To: T10 Technical Committee  
From: Rob Elliott, HP (elliott@hp.com)  
Date: 30 May 2007  
Subject: 07-091r3 SAS-2 SMP DISCOVER support for SNW-3 phy capabilities

Revision 3 (30 May 2007) Incorporated comments from May 2007 SAS protocol WG - added a NEGOTIATED SSC BIT to DISCOVER, clarified meaning of "supported" and "valid" in SNW text. Moved PHY CONTROL changes to a separate proposal. Restored supported settings priority table for the settings bits from 06-515r0 (which was missed when that proposal was incorporated into sas2r08).

**Figure A.1 — SAS speed negotiation sequence (phy A: SNW-1 only, phy B: SNW-1 only) [\[modified\]](#)**

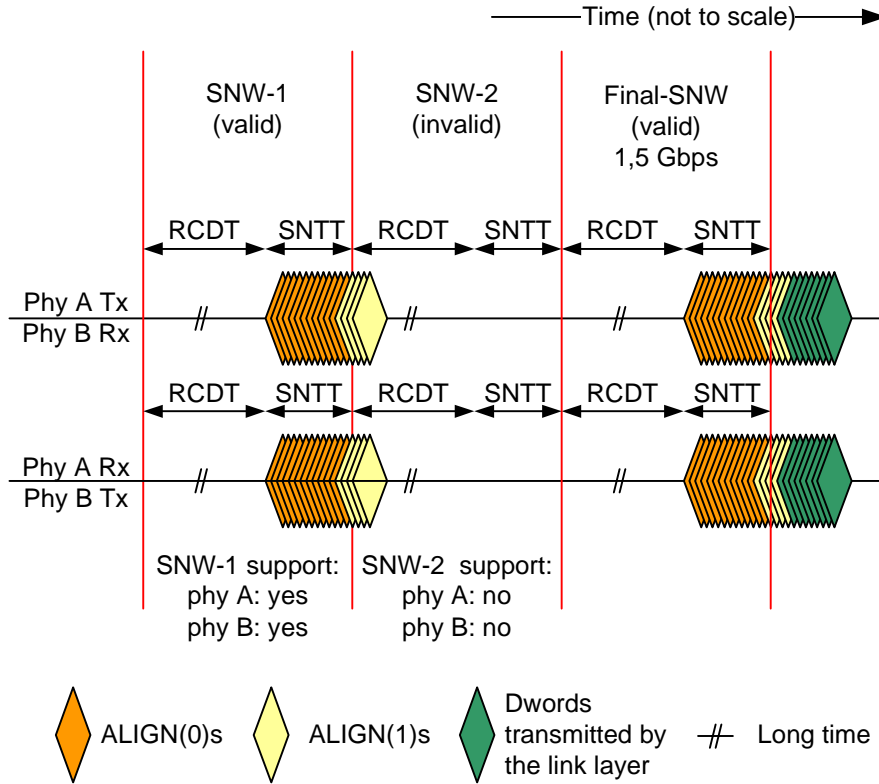
Figure A.1 shows a speed negotiation between a phy A that supports only SNW-1 attached to a phy B that only supports SNW-1. Both phys run:

**Figure A.2 — SAS speed negotiation sequence (phy A: SNW-1, SNW-2, phy B: SNW-1, SNW-2). [\[modified\]](#)**

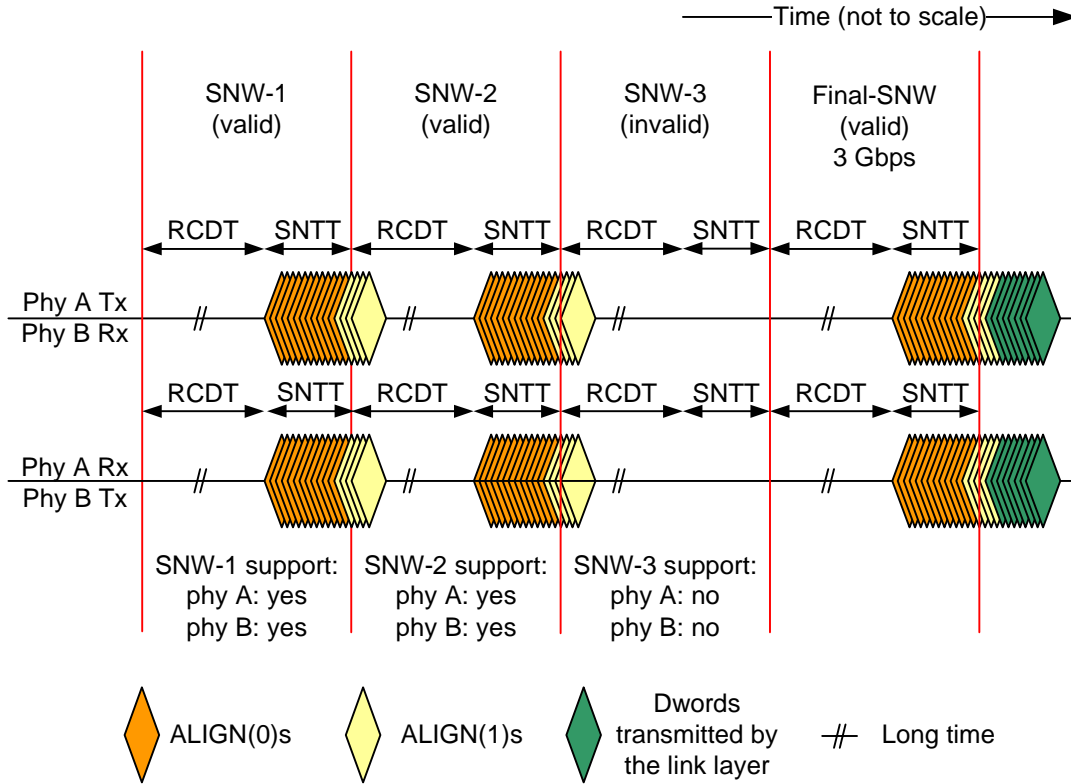
Figure A.2 shows a speed negotiation between a phy A that supports SNW-1 and SNW-2 attached to a phy B that supports SNW-1 and SNW-2. Both phys run:

**Figure A.3 — SAS speed negotiation sequence (phy A: SNW-1, SNW-2, SNW-3, phy B: SNW-1, SNW-2). [modified]**

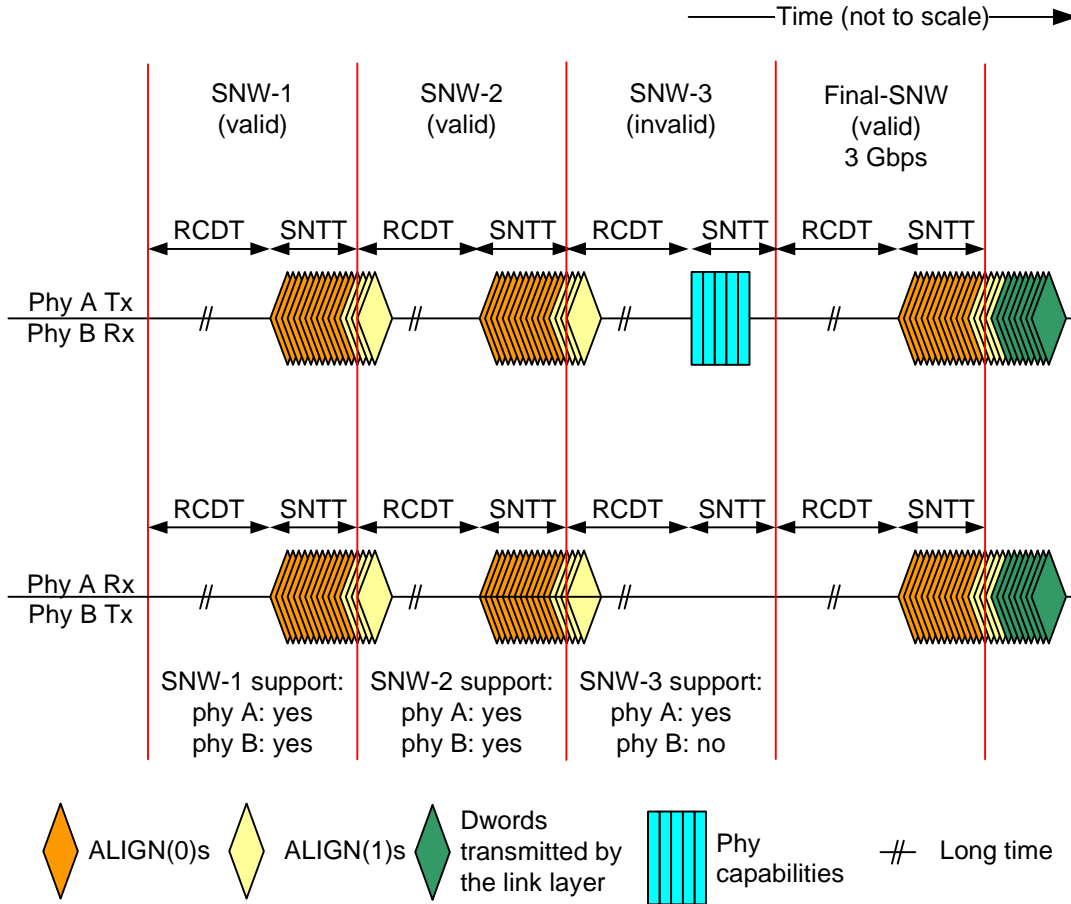
Figure A.3 shows a speed negotiation between a phy A that supports SNW-1 through SNW-3 attached to a phy B that only supports SNW-1 and SNW-2. Both phys run:

**Figure A.4 — SAS speed negotiation sequence (phy A: SNW-2, SNW-3, phy B: SNW-1, SNW-2). [modified]**

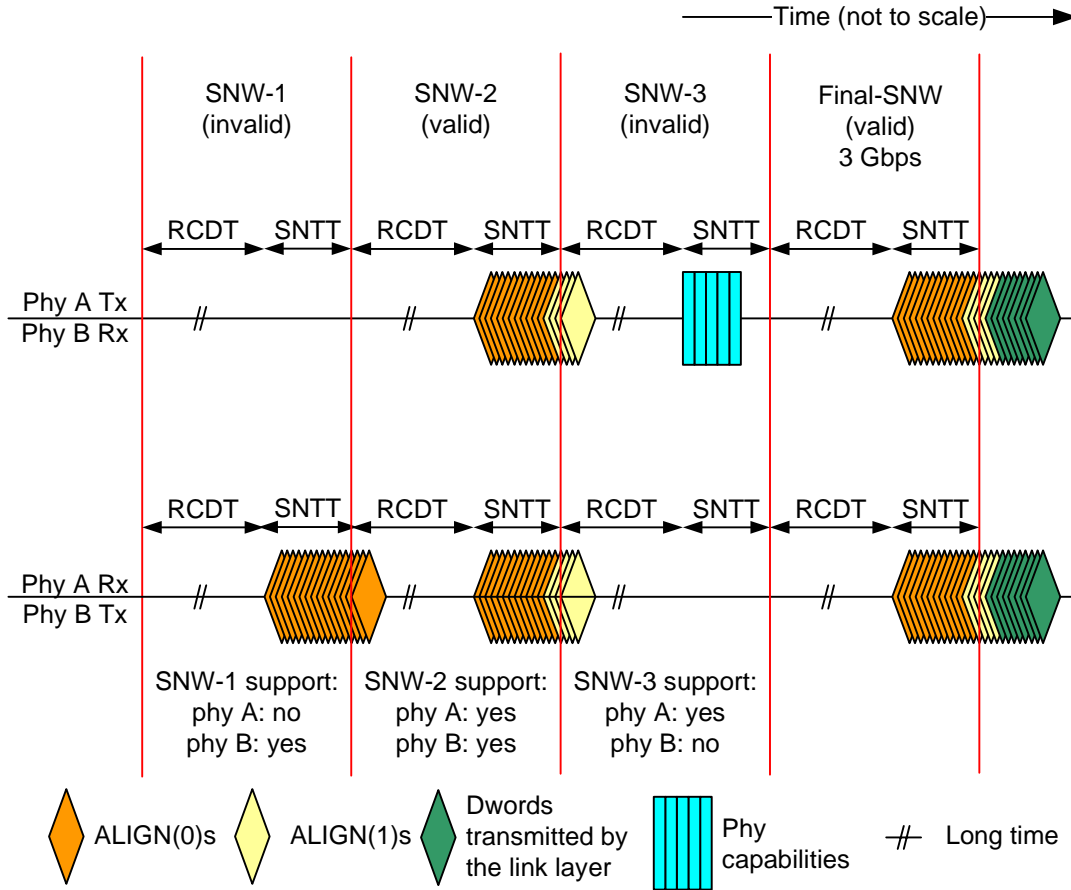
Figure A.4 shows a speed negotiation between a phy A that supports SNW-2 and SNW-3 attached to a phy B that only supports SNW-1 and SNW-2. Both phys run:

Figure A.5 — SAS speed negotiation sequence (phy A: SNW-1 only, phy B: SNW-2 only) [\[modified\]](#)

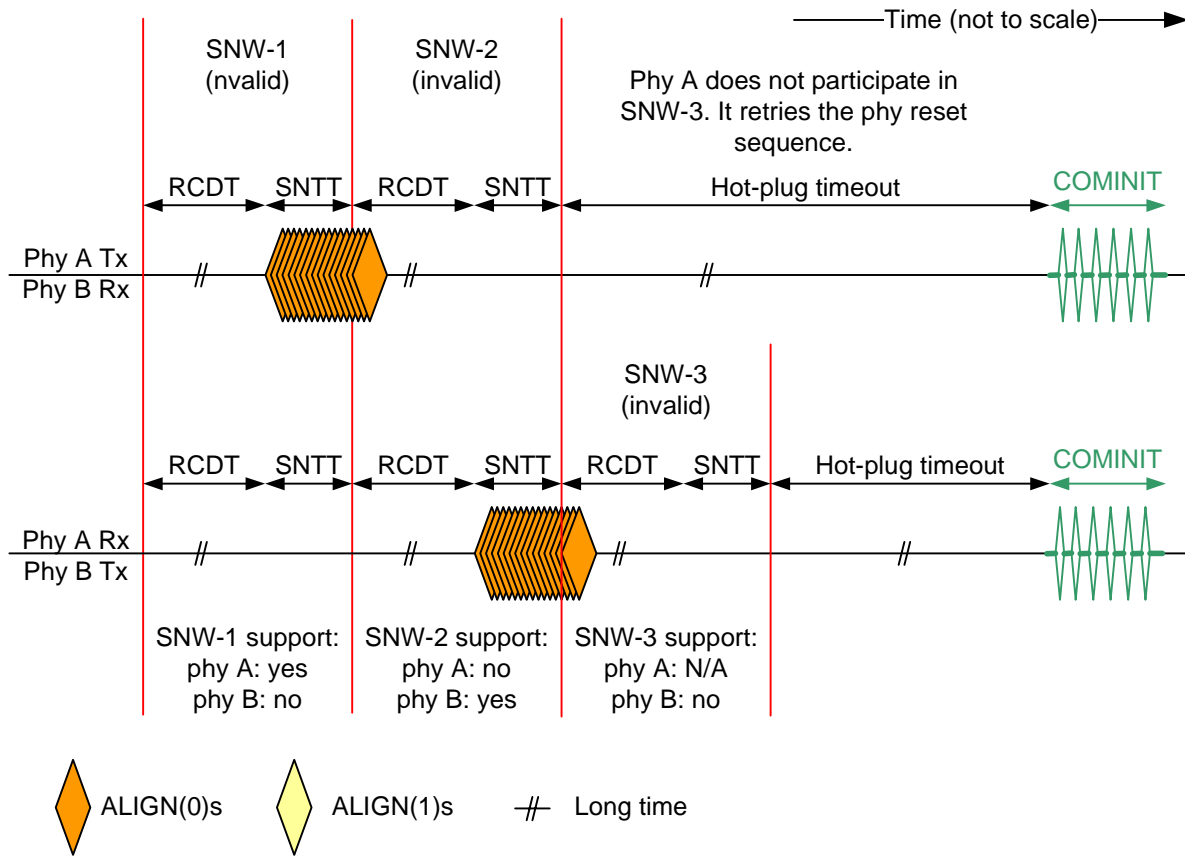
Figure A.5 shows a speed negotiation between a phy A that only supports SNW-1 attached to a phy B that only supports SNW-2. Both phys run:
